**Re:** Clean Air Coalition Comment on Site Number: C915353 Riverview Innovation & Technology Campus Brownfield Cleanup Site- Remedial Investigation Work Plan

The Clean Air Coalition respectfully submits the following comments regarding the Remedial Investigation Work Plan for Riverview Innovation & Technology Campus, Inc. for a site known as Riverview Innovation and Technology Campus (former Tonawanda Coke plant), Site Number: C915353.

**Cross Section A-A'**

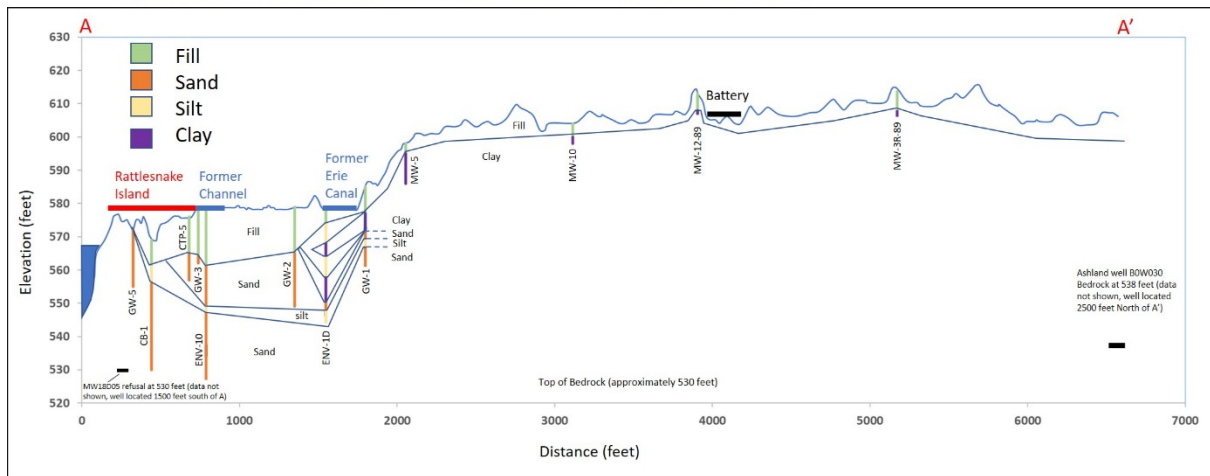
Paragraph 3: The RIWP characterization of the geology of the BCP Site may be overly simplistic.

Analysis: The clay deposits 1.5 miles to the east occurred in a completely different geological environment than those sediments directly downgradient and close to the Niagara River. As shown in the ESA cross section below, data from the Roblin Steel Site corroborates other data from work at the Huntley Power Plant immediately to the south. It shows the effect of a fluvial and possibly another higher energy depositional environment with sand and units of much higher permeability closer to the river. The closest downgradient log exhibits silt and sand deposits at depth, complicating the interpretation of the geology, on the western boundary of the site at least, without more information. As will also be discussed in more detail in later comments, the morphology of bedrock ridges under the BCP Site may further complicate matters.

Requested RIWP Revisions: This comment helps lay the groundwork for other comments later in the document. No revisions are necessarily required, but Inventum may choose to augment its discussion with this cross section and the additional information made available in the ESA.

**Comment 11: Geologic Complexity, Groundwater Flow Direction and Discharge**

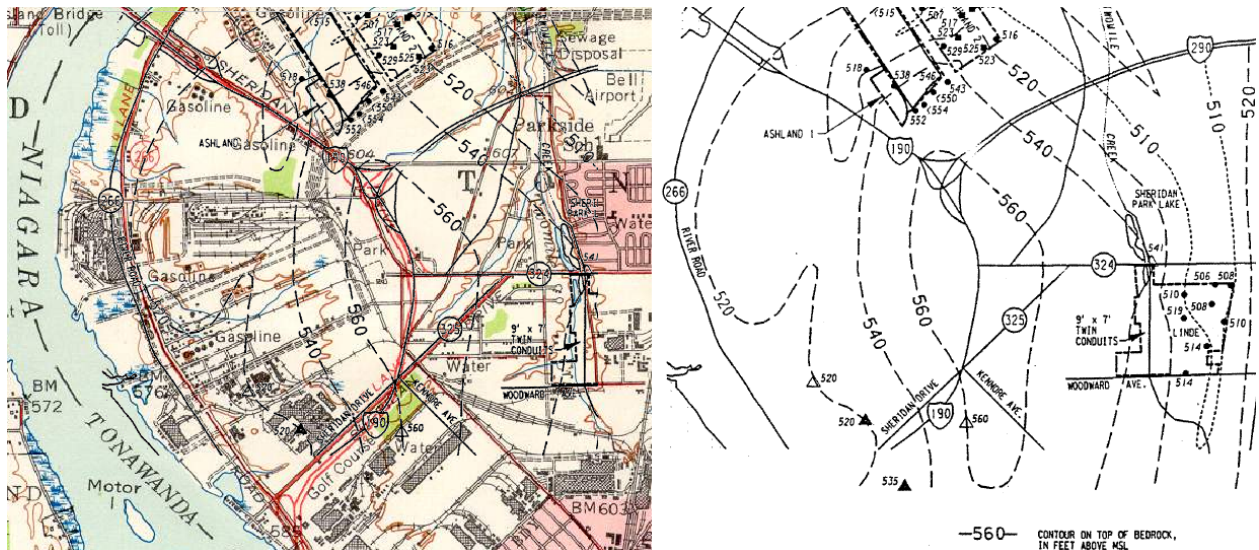
General: The RIWP discusses the occurrence of groundwater in fill, clay and bedrock, and the possibility of a vertical gradient, but does not address groundwater flow, extraction or discharge.

Analysis: The RIWP does not discuss horizontal groundwater flow or the Niagara River as the local groundwater discharge zone, an important receptor particularly in light of the occurrence of higher permeability layers at the western border of the site as shown in the cross section in the earlier comment. Further, while groundwater in the area is not used for drinking, according to a NYSDEC Region 9 special report, at least one large capacity production well is located within a half-mile, seasonally controlling groundwater flow in bedrock just to the south of the BCP site. Other regional studies indicate localized groundwater flow to the north in the vicinity of the BCP Site as well. Without some control points to understand groundwater flow in bedrock, the flow direction will remain unknown.

Requested RIWP Revisions: Horizontal flow and groundwater discharge should be addressed in this section. This comment helps lay the groundwork for other comments on this subject later in the document.

**Comment 29: Byproduct Area Investigation**

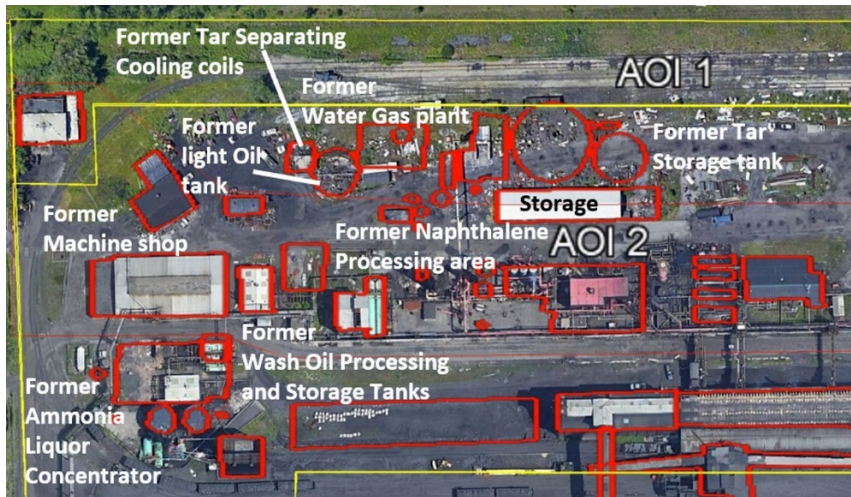
Byproduct Area within AOI2: The RIWP does not recognize the extensive processing of specific byproducts and the generation of large amounts of potentially hazardous chemicals generated in those byproduct processing areas within AOI-2.

Analysis: nygeology, through extensive research, has uncovered data not available to Inventum and determined the likely locations of specific byproduct processing units and the specific chemicals that were likely used or generated at them. With the exception of the welding shop, which was formerly a machine shop likely working with solvents, the infrastructure associated with the specific byproduct areas of concern has been removed. For a complete analysis of the nature and locations of these former units, refer to the ESA and digital file attachments. These specific areas of concern are listed below and shown in the figure.

Test pits will need to be dug at each identified location to examine the impact of these byproduct processing operations. While the locations of the planned BCP pits do not change, certain BCP pits could be shortened and used to investigate the byproduct management units as discussed later in these comments. For the purposes of these comments, we have identified these pits as “community” test pits with the designation COM Test Pits to avoid confusion with the planned BCP Test Pits.

Requested RIWP Revisions: Add the additional information referenced herein to the RIWP to lay out the rationale for the additional test pit work in the byproduct processing area. Regarding the specifics of the COM Test Pits, refer to comments made herein to the RIWP Sections 5.3 Test Pits and 8.1 Interim Site Management.

**Comment 48: COM Test Pit Additions and BCP Test Pit Reductions**

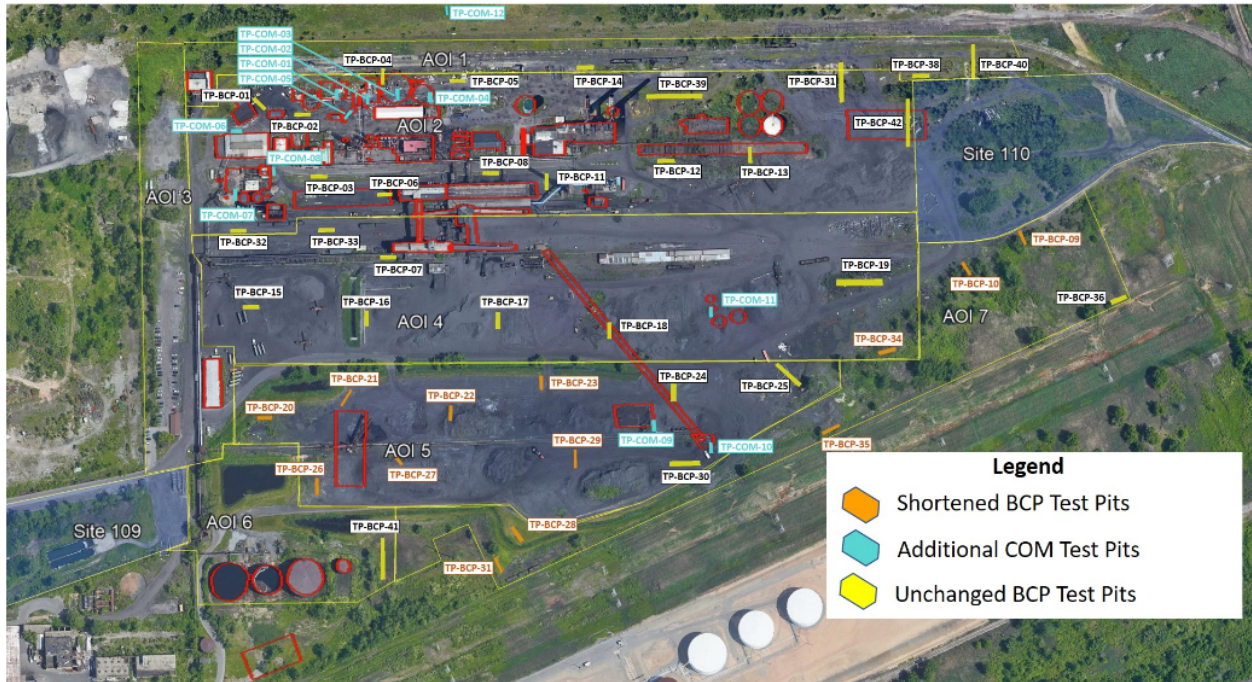
As presented earlier in Comment 20 on historic byproduct operations, this section provides the details for the modification of BCP Test Pits and the installation of each COM Test Pit. The following map shows the locations of all test pits envisioned to be installed at the site:

Out of respect for the resources that must be dedicated to implement this workplan, we have attempted to preserve the level of test pit work activity by shortening some pits and redistributing them to other areas for investigation. TP-BCP 1-8, 11-19, 24, 25, 30, 32, 33, 36-42, marked as yellow polygons on the map, do not need to be modified from the original BCP workplan. Modifications to the test pit program are discussed further below.

**BCP Test Pit Modifications:** Several of the BCP workplan test pits are in locations where there was limited to no historical activity. We believe these test pits can be reduced in size while still providing the same level of sampling information. Specifically, TP-BCP-9, 10, 20, 21, 22, 23, 26, 27, 28, 29, 31, 34, and 35 are identified as test pits that can be reduced in length. The modified test pits are identified as orange polygons on the above map. The rationale for shortening these test pits along with the recommended length for each is presented below:

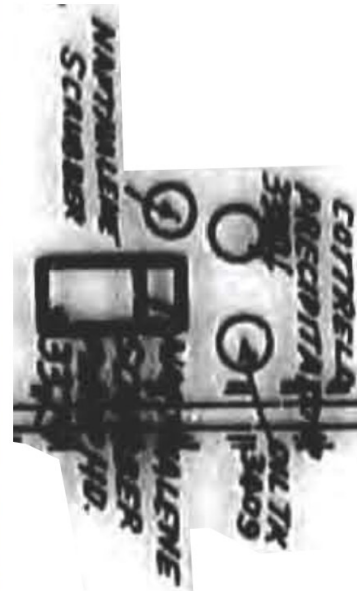
*TP-COM-3 Former Light Oil Tank:* As shown below, the new test pit will be placed as close to the former light oil tank as possible. This test pit is located in RIWP grid square Q-4. Sample analysis should include VOCs, SVOCs, cyanide, metals and mercury.

*TP-COM-4 Former Tar Storage Tank:* As shown above, the new test pit will be placed as close to the former tar storage tank as possible. This test pit is located in RIWP grid square S-4. Sample analysis should include VOCs, SVOCs, cyanide, metals and mercury.

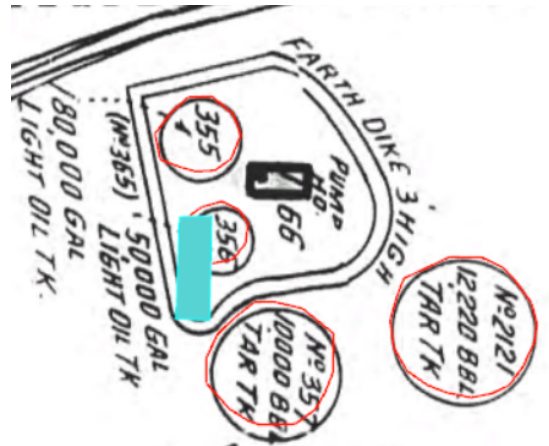
TP-COM-9 Mixing Pad: This provisional test pit has been added in the event that this area is not part of a separate IRM investigation. As shown below, the new test pit will be placed as close to the concrete mixing pad as possible. This test pit is located in RIWP grid square AG-26. Sample analysis should include VOCs, SVOCs, cyanide, metals and mercury.
